### Statter Harbor Improvements Contract No. DH14-014

**ADDENDUM NO.:** TWO

**DATE ADDENDUM ISSUED:** **October 1, 2014**

**3.04**  
SHEET  
30 OF 82

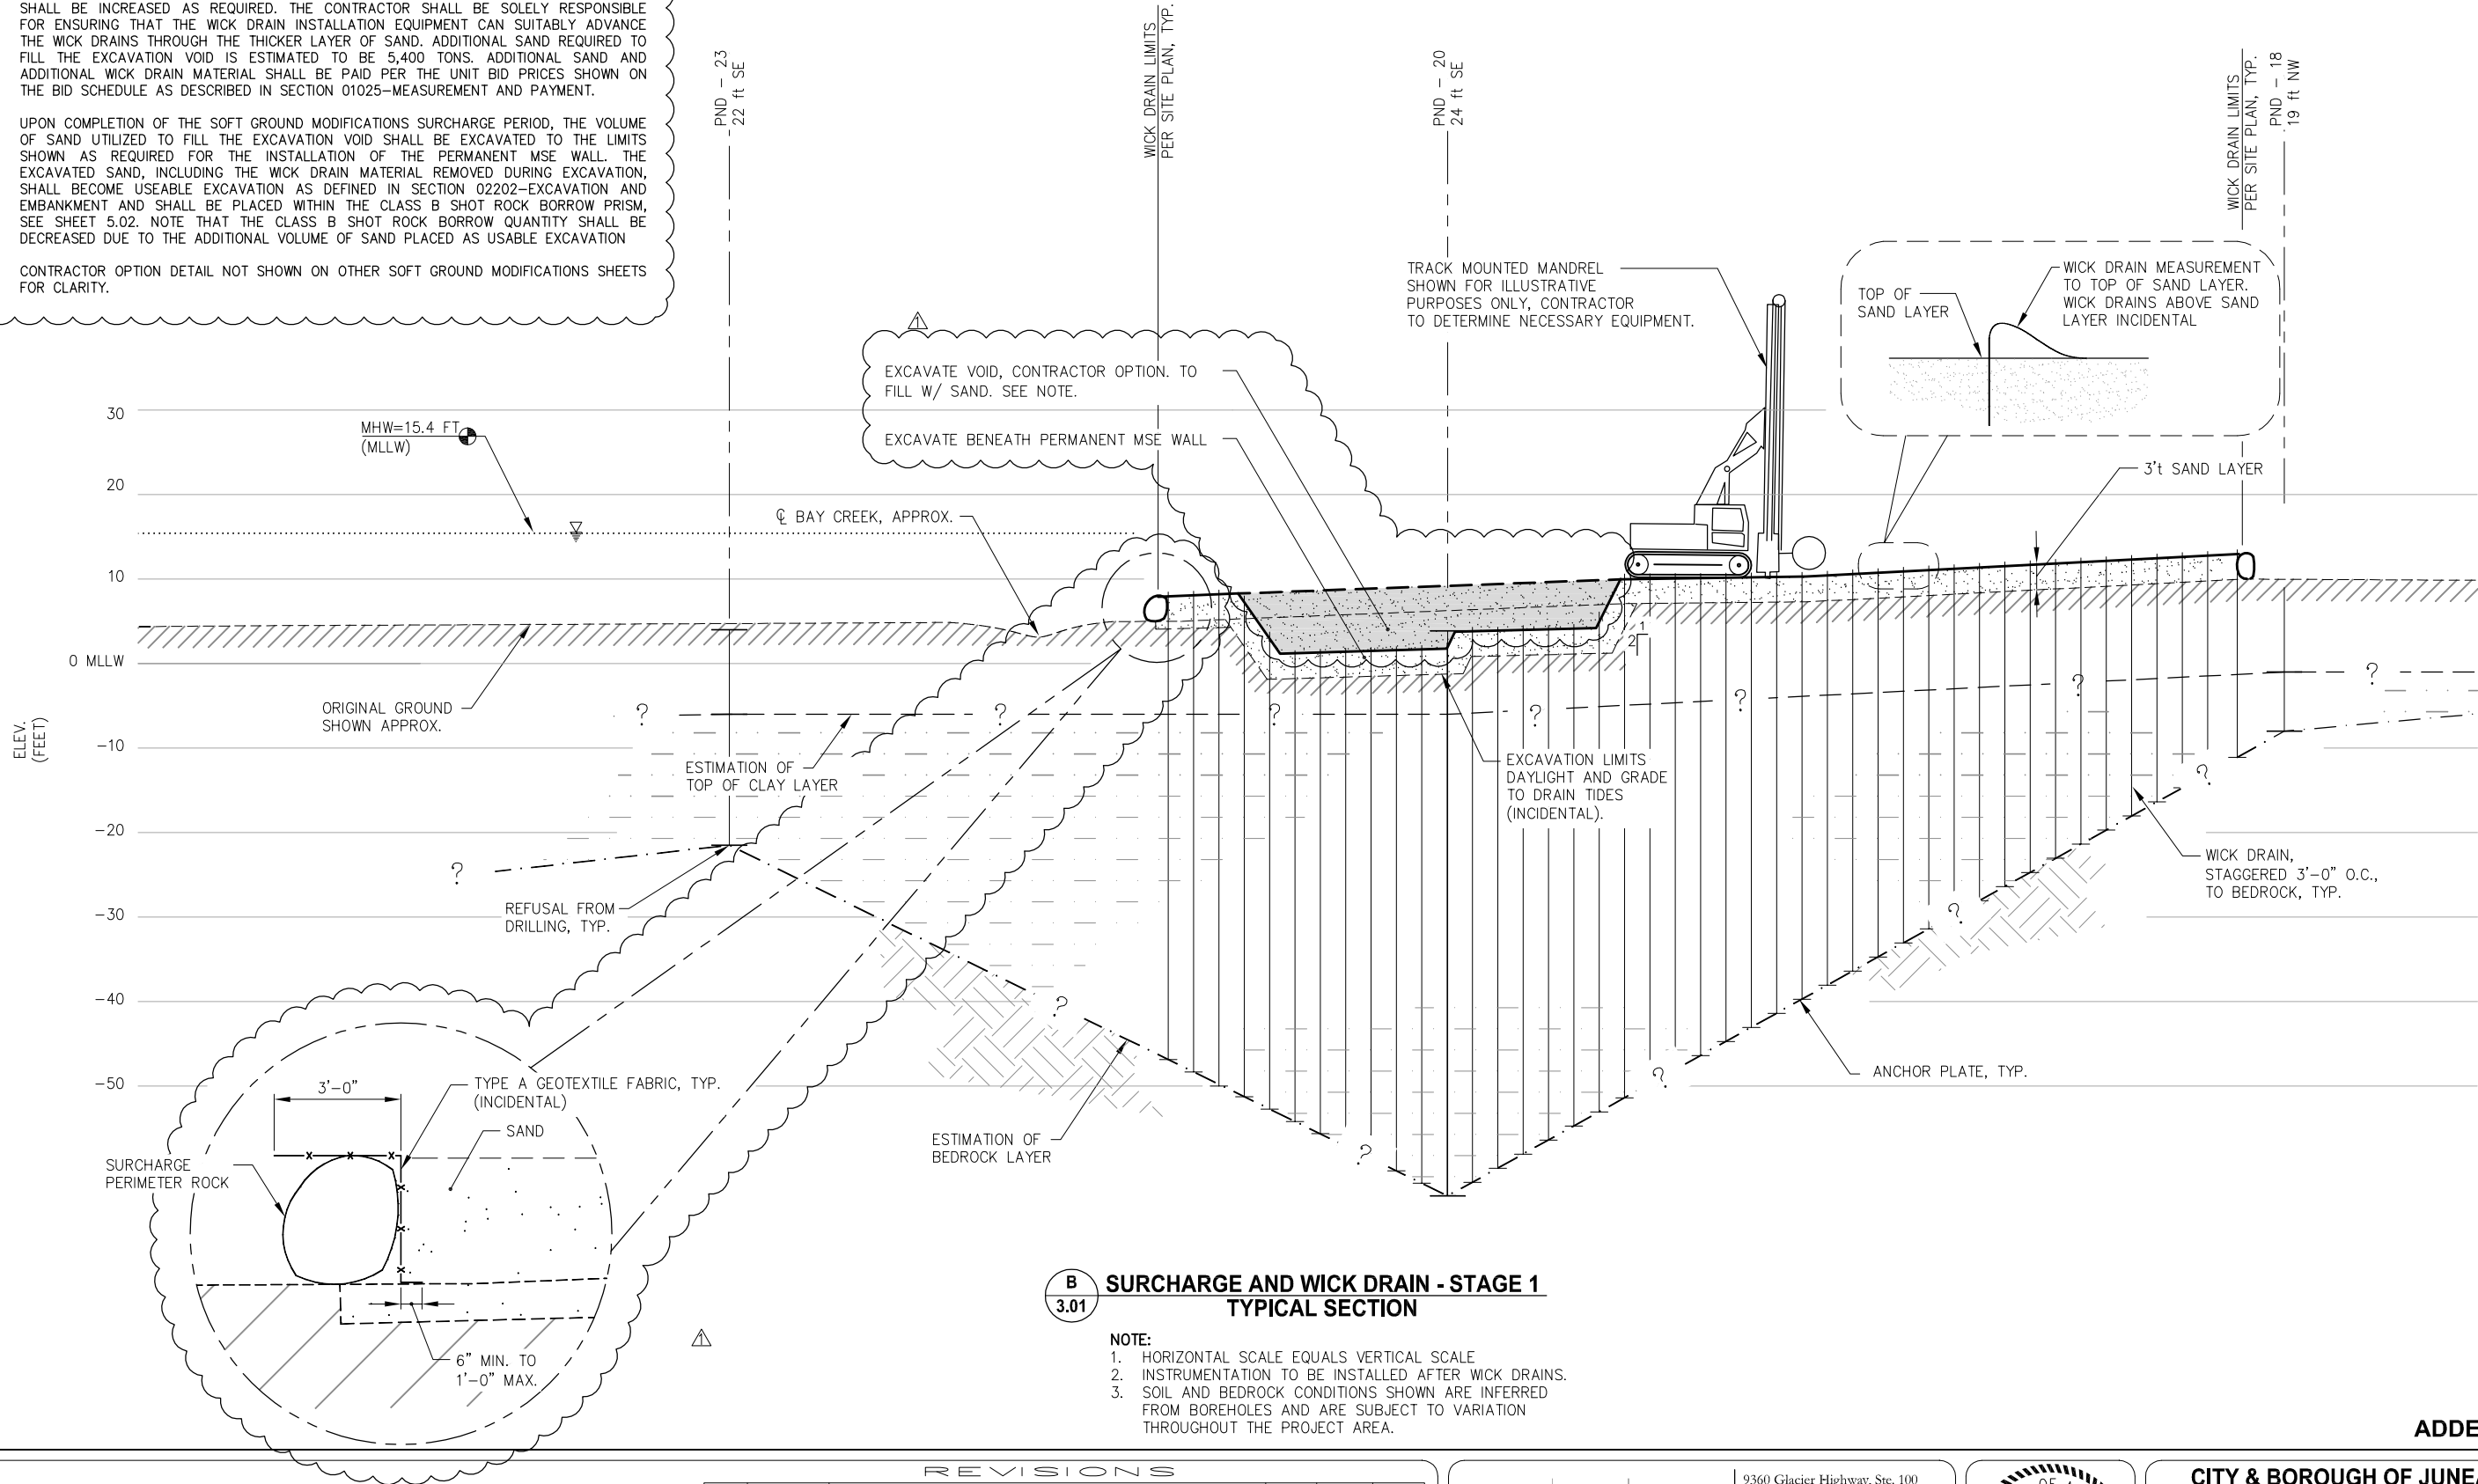
Item No. 23 **Replace** DRAWING SHEET 3.04, SOFT GROUND MODIFICATIONS SURCHARGE STAGE 1 AND WICK DRAIN SECTION with the attached sheet, similarly titled and dated October 1, 2014.

REVISIONS					
REV.	DATE	DESCRIPTION	DWN.	CKD.	APP.
1	10/1/14	ADDENDUM 2-ADD GEOTEXTILE AND SAND LAYER OPTION	KLL	PLR	CRS

NOTE, CONTRACTOR OPTION:

1. TO FACILITATE WICK DRAIN INSTALLATION, THE CONTRACTOR MAY, AT HIS OWN DISCRETION, ELECT TO BACKFILL THE AREA OF EXCAVATION BENEATH THE PERMANENT MSE WALL WITH SAND TO CONSTRUCT A LEVEL SURFACE AS SHOWN. THE LENGTH OF THE WICK DRAINS SHALL BE INCREASED AS REQUIRED. THE CONTRACTOR SHALL BE SOLELY RESPONSIBLE FOR ENSURING THAT THE WICK DRAIN INSTALLATION EQUIPMENT CAN SUITABLY ADVANCE THE WICK DRAINS THROUGH THE THICKER LAYER OF SAND. ADDITIONAL SAND REQUIRED TO FILL THE EXCAVATION VOID IS ESTIMATED TO BE 5,400 TONS. ADDITIONAL SAND AND ADDITIONAL WICK DRAIN MATERIAL SHALL BE PAID PER THE UNIT BID PRICES SHOWN ON THE BID SCHEDULE AS DESCRIBED IN SECTION 01025-MEASUREMENT AND PAYMENT.

2. UPON COMPLETION OF THE SOFT GROUND MODIFICATIONS SURCHARGE PERIOD, THE VOLUME OF SAND UTILIZED TO FILL THE EXCAVATION VOID SHALL BE EXCAVATED TO THE LIMITS SHOWN AS REQUIRED FOR THE INSTALLATION OF THE PERMANENT MSE WALL. THE EXCAVATED SAND, INCLUDING THE WICK DRAIN MATERIAL REMOVED DURING EXCAVATION, SHALL BECOME USEABLE EXCAVATION AS DEFINED IN SECTION 02202-EXCAVATION AND EMBANKMENT AND SHALL BE PLACED WITHIN THE CLASS B SHOT ROCK BORROW PRISM, SEE SHEET 5.02. NOTE THAT THE CLASS B SHOT ROCK BORROW QUANTITY SHALL BE DECREASED DUE TO THE ADDITIONAL VOLUME OF SAND PLACED AS USABLE EXCAVATION
